ADDENDUM NO.: THREE

DATE OF ADDENDUM: April 4, 2014

**JOYNER HALL
NORTHWESTERN CONNECTICUT COMMUNITY COLLEGE
WINSTED, CT
BI – CT – 427**

TYPICAL AHU CONTROL SCHEMATIC (AHU-2, AHU-3)
NOT TO SCALE

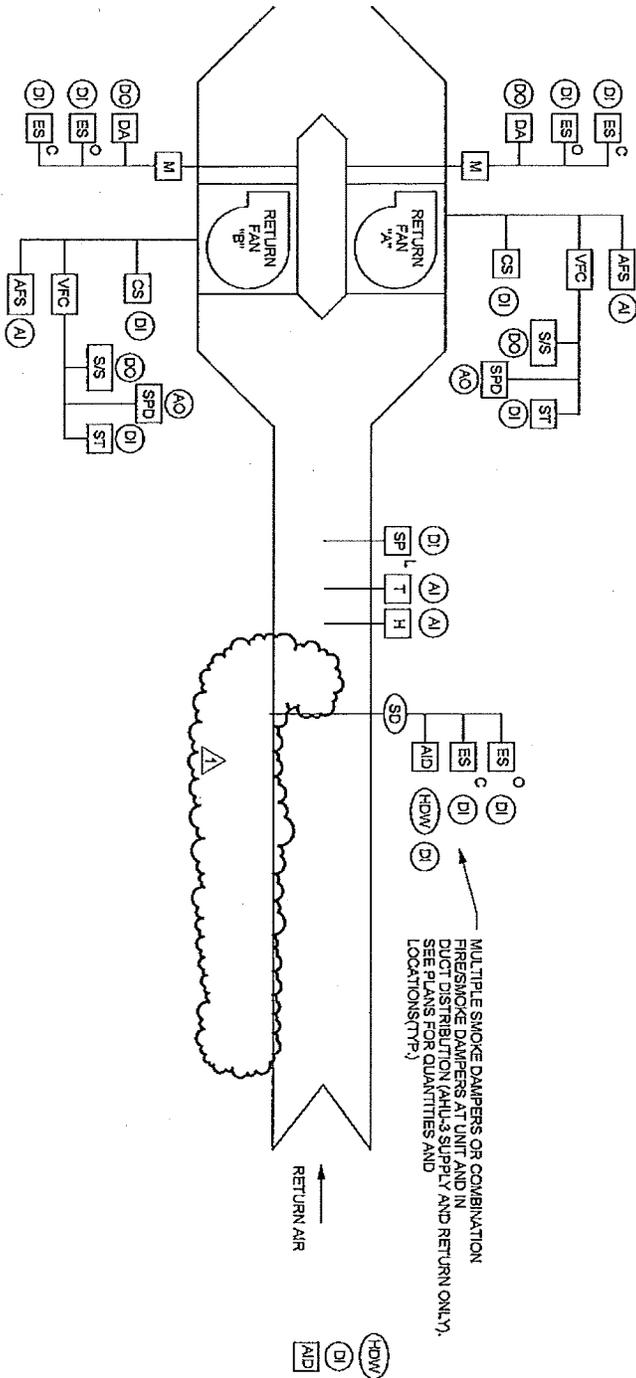
Clarification: Deleted duct smoke from the return air ductwork. Refer to sketch ADH-07 attached to this addendum.

DUAL FAN AIR HANDLER CONTROL (AHU-1S & AHU-1E)
 NOT TO SCALE

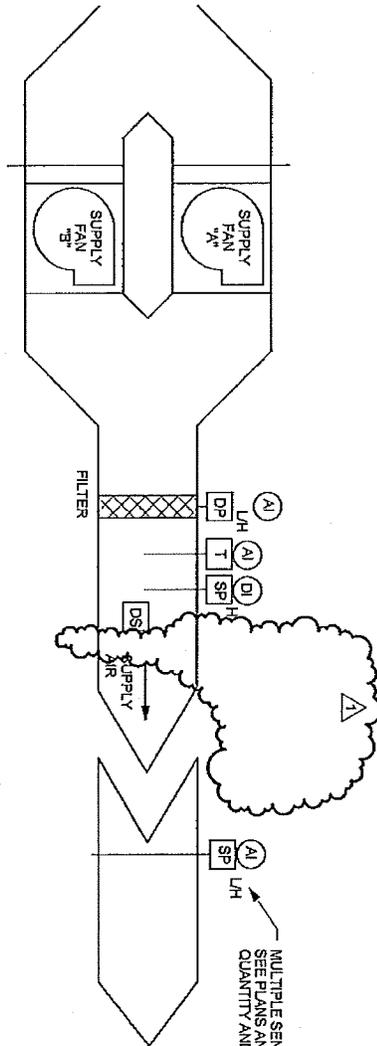
Clarification: Deleted duct smoke from the return air ductwork. Refer to sketch ADH-08 attached to this addendum.

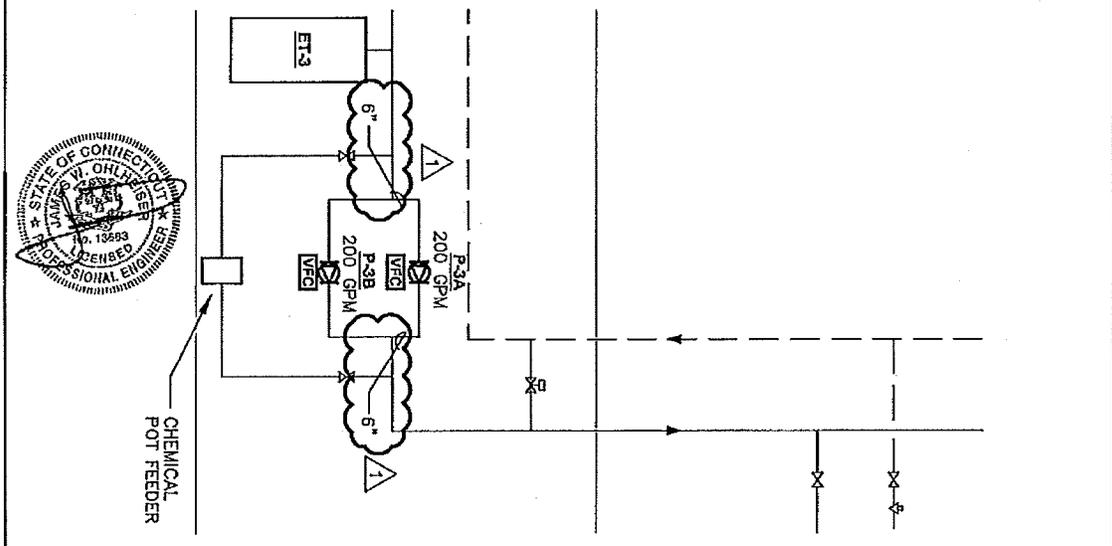
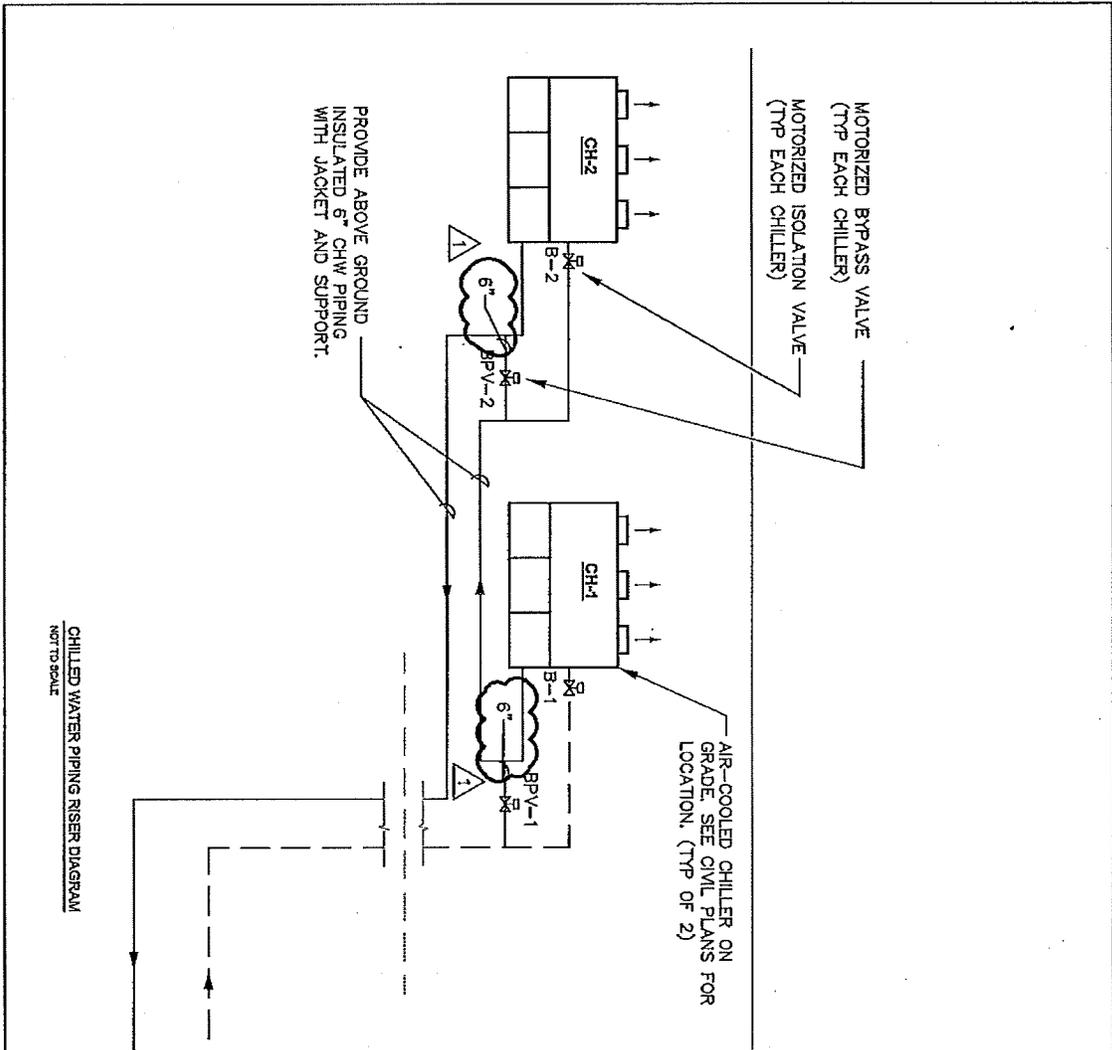
Clarification: Added pipe sizes for chiller pumps and chiller connections. Refer to sketch ADH-09 attached to this addendum.

1 MAIN LEVEL ELECTRICAL POWER PLAN
 JOYNER 1/8" = 1'-0"

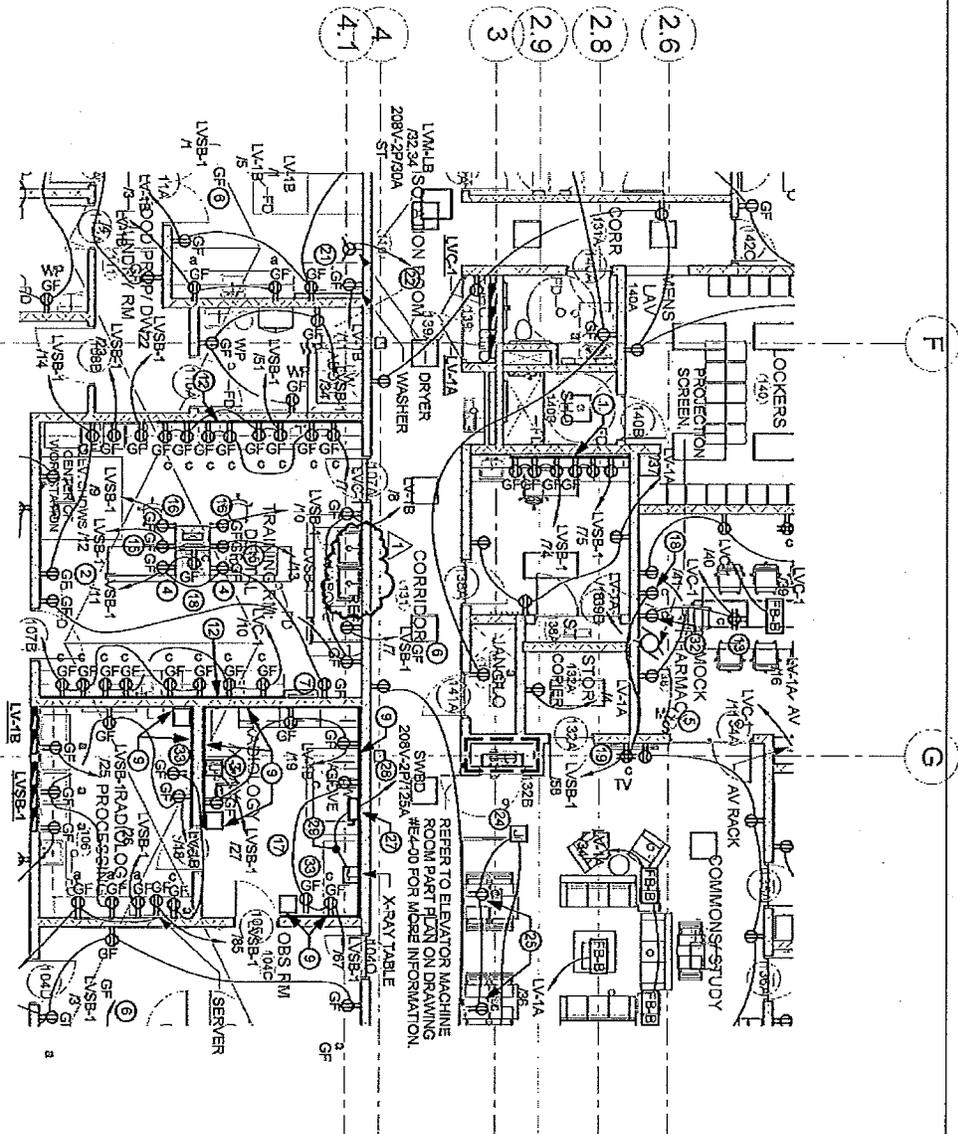
Clarification: Deleted two duplex outlets located above the dual sink in Training Dental room 107. Refer to sketch ADEP-01 attached to this addendum.

1 BASEMENT LEVEL ELECTRICAL SPECIAL SYSTEMS PLAN
 ADES-01 1/8" = 1'-0"

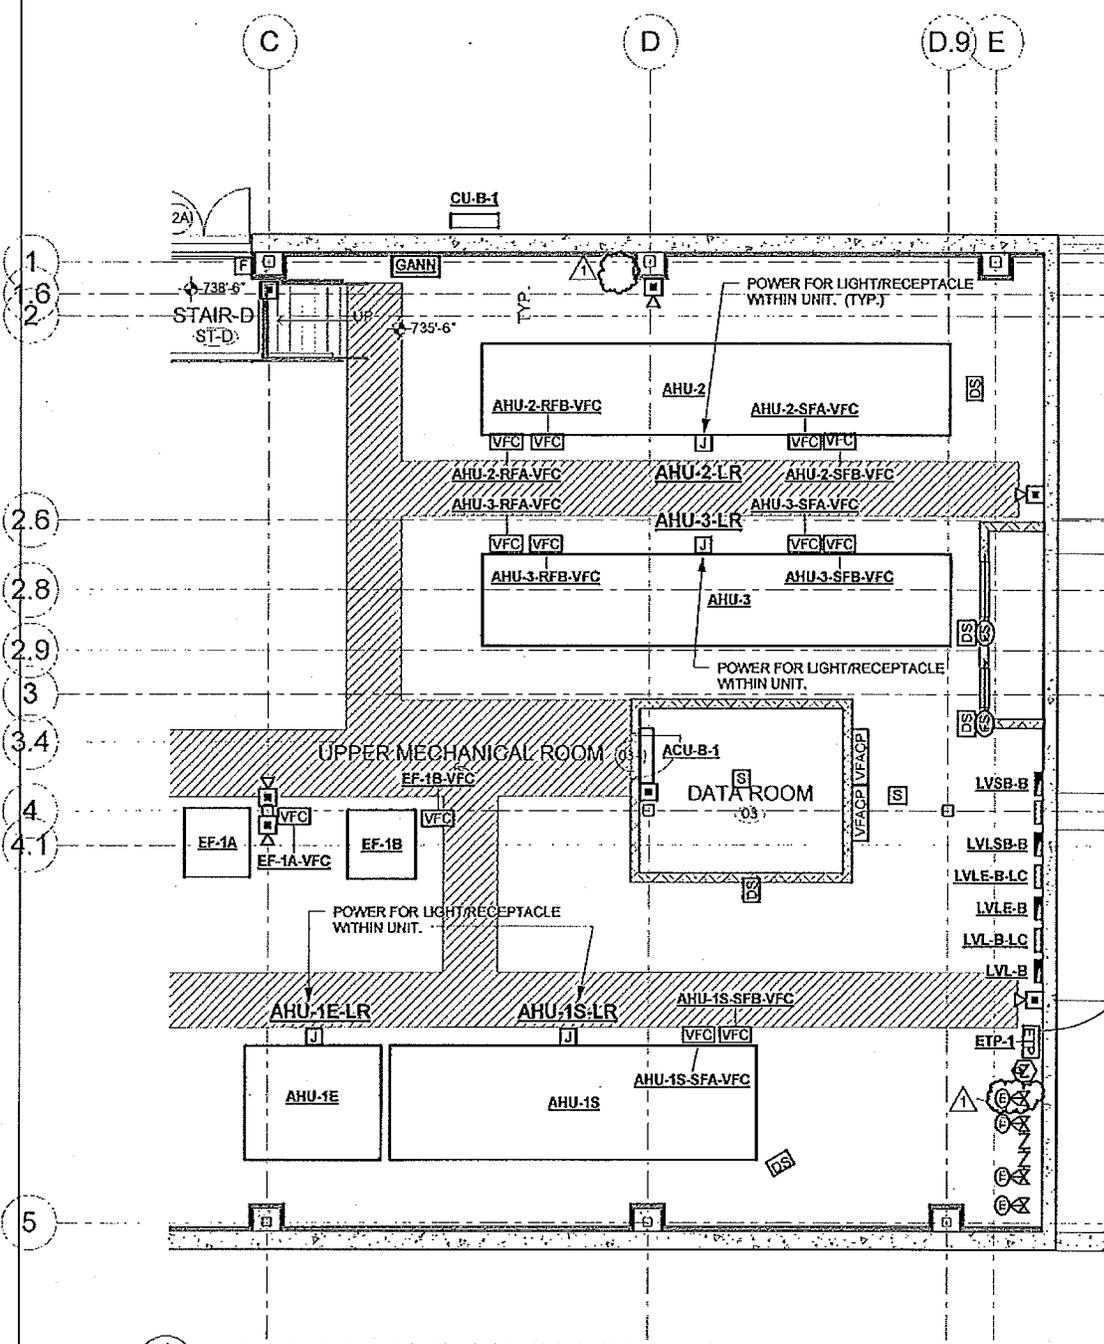
Clarification: Revisions to duct smoke detectors location and quantity in the basement, added one more tamper switch. Refer to sketch ADES-01 attached to this addendum.

1 GAS NOTE EDITS, ADD TELEPHONE LINE TO GAS METER
 ADC-02 1" = 20'

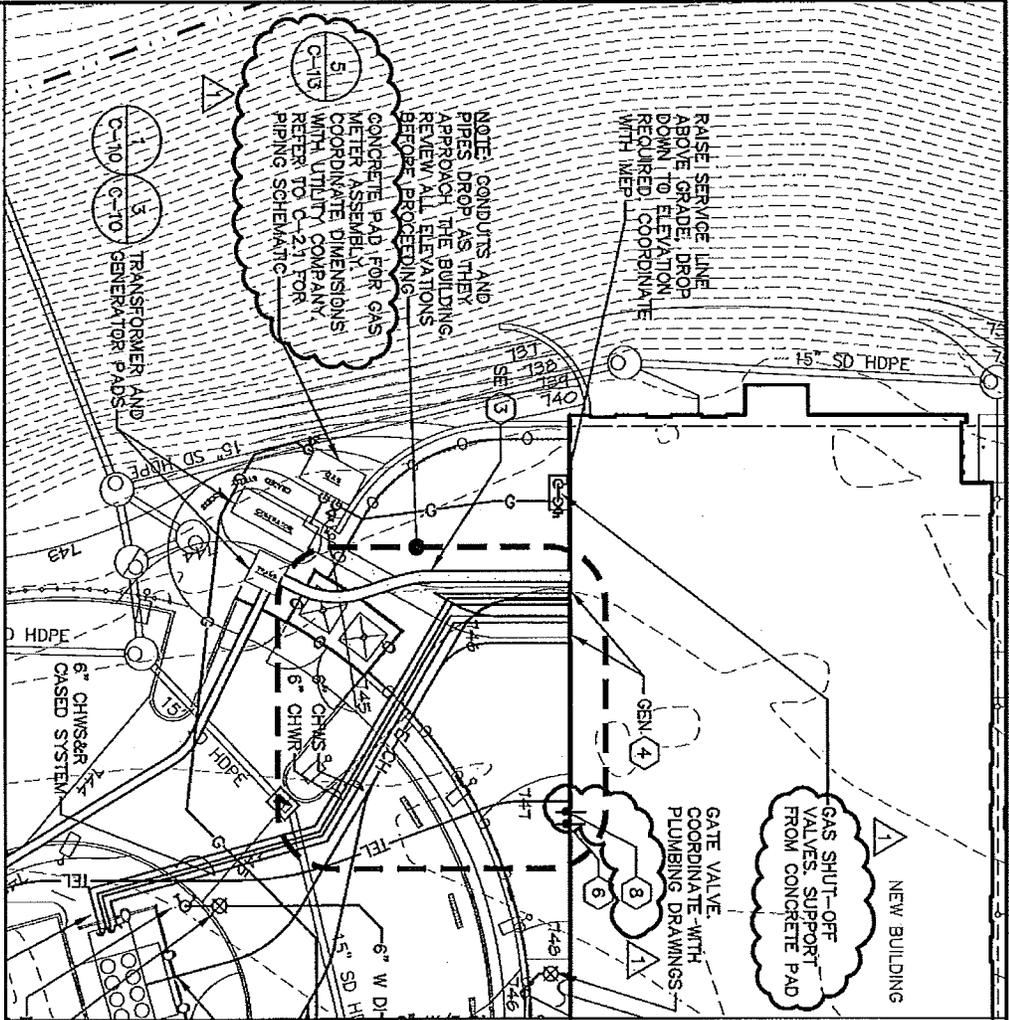
Clarification: Revised gas utility notes, added conduit to drawing and schedule (#8) for telephone line to gas meter. Refer to sketch ADC-02 attached to this addendum.

1 SANITARY SEWER INVERT REVISIONS
 ADC-03 1" = 20'

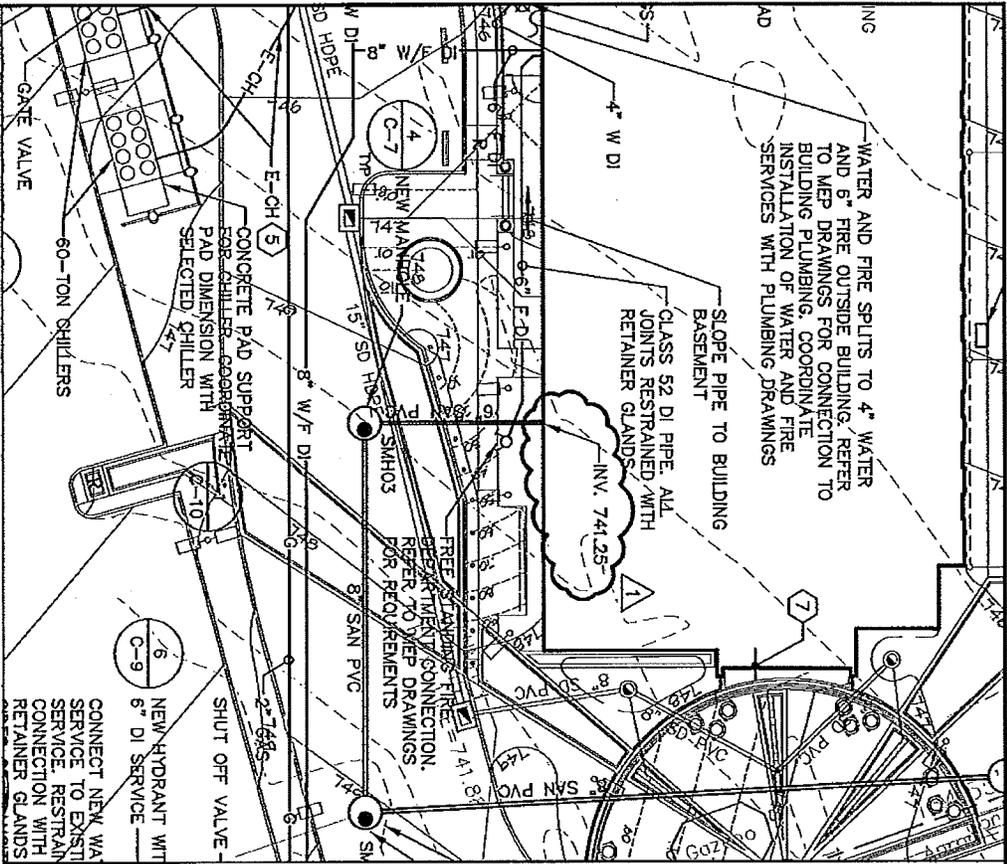
Clarification: Revised sanitary inverts to raise invert at building from 740.25 to 741.25. Refer to sketch ADC-03 attached to this addendum.

GAS UTILITY EDITS, REVISE GENERATOR LOCATION

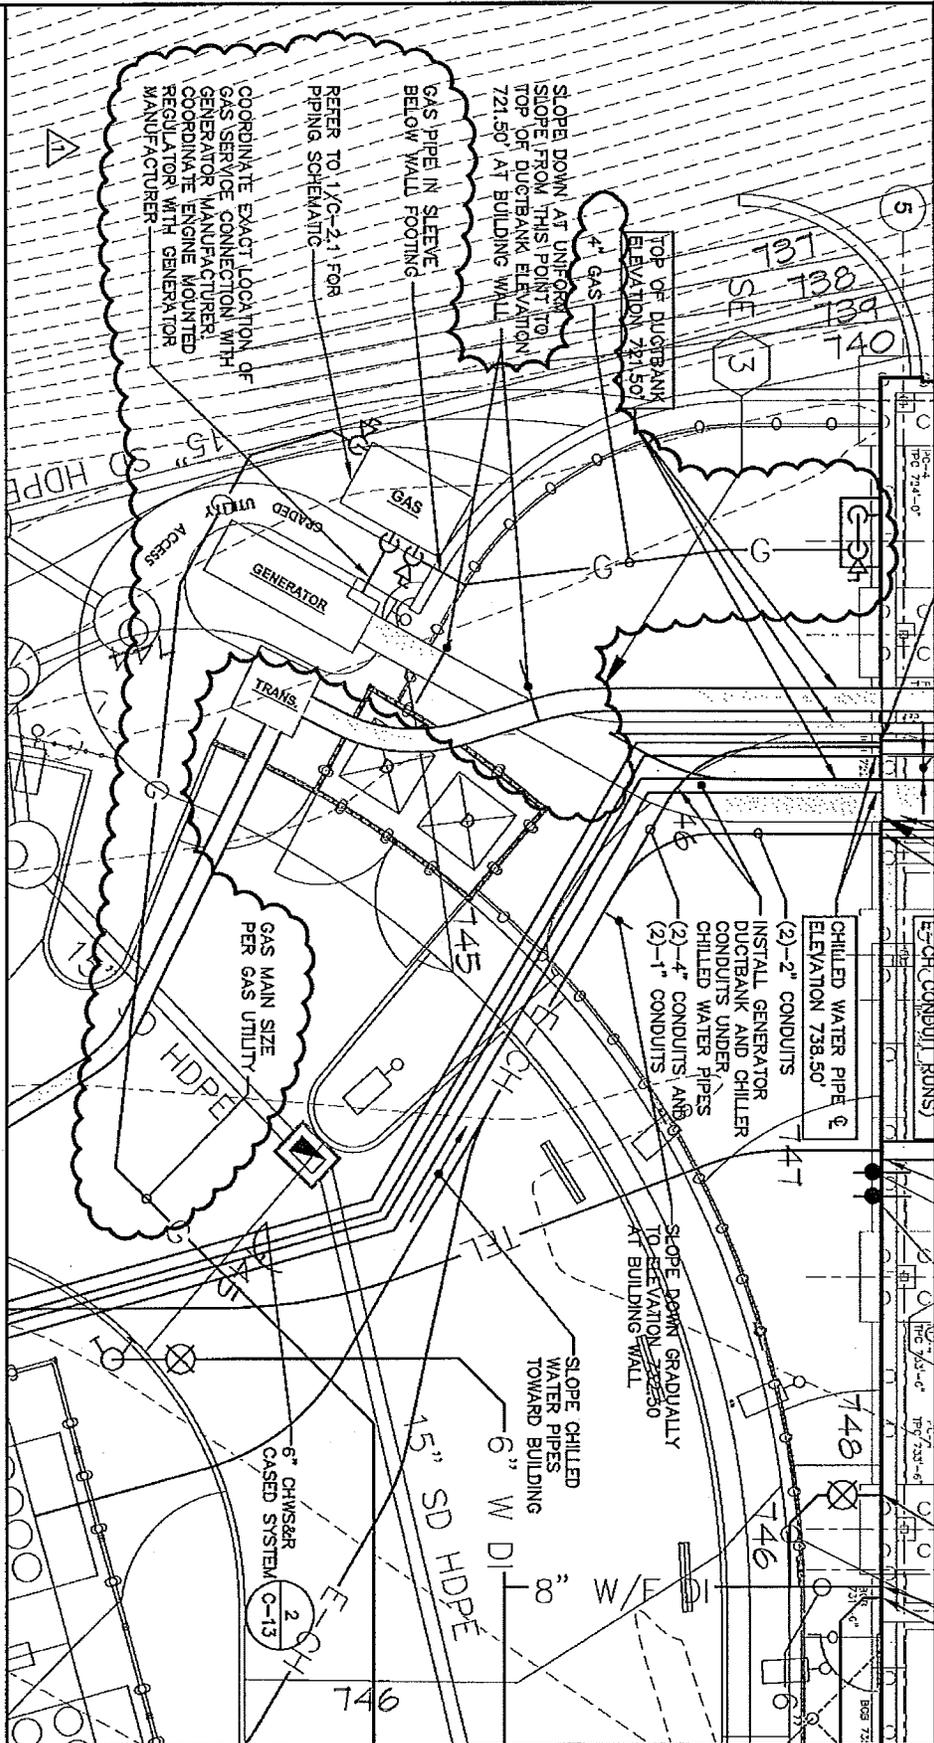
Clarification: Revised locations of gas meter pad, generator pad, and transformer pad, reconfigured gas utility, revised gas notes. Refer to sketch ADC-05 attached to this addendum.

1 GAS METER PIPING SCHEMATIC
 ADC-06/ NOT TO SCALE

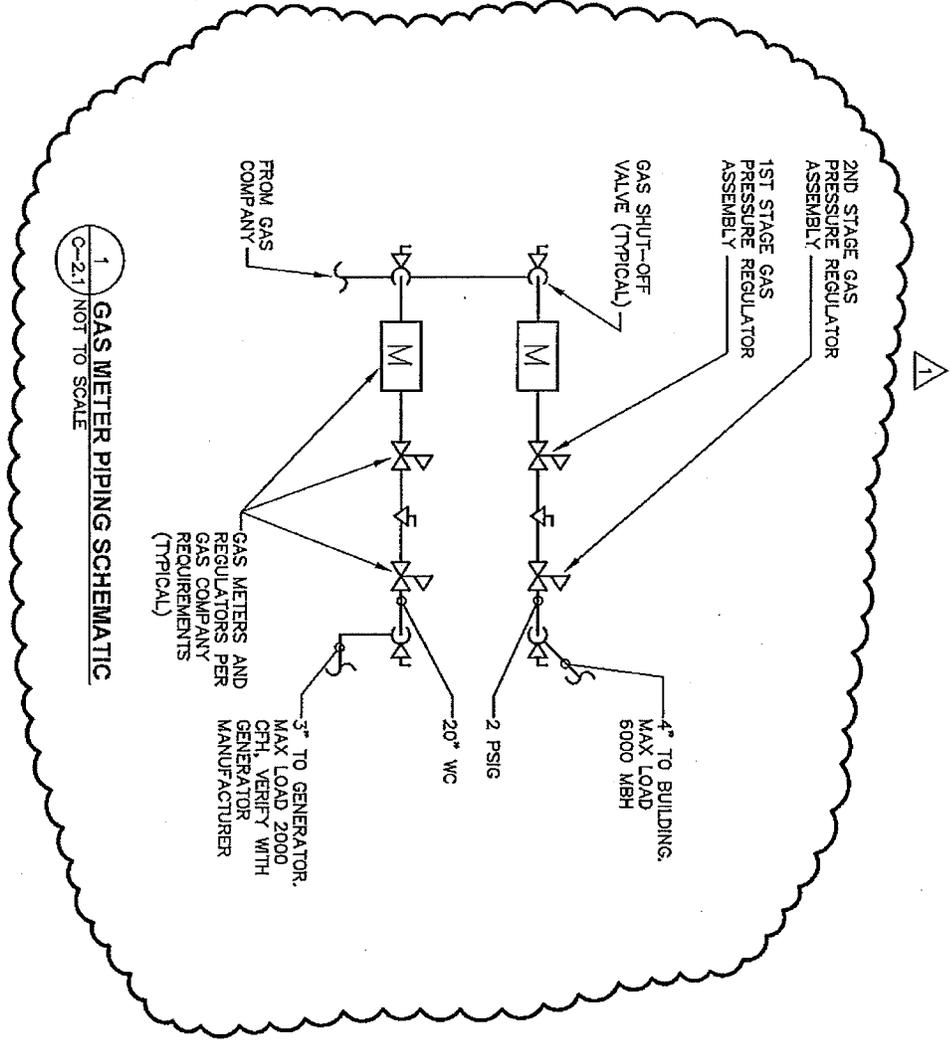
Clarification: Added gas meter piping schematic to drawings. Refer to sketch ADC-06 attached to this addendum.
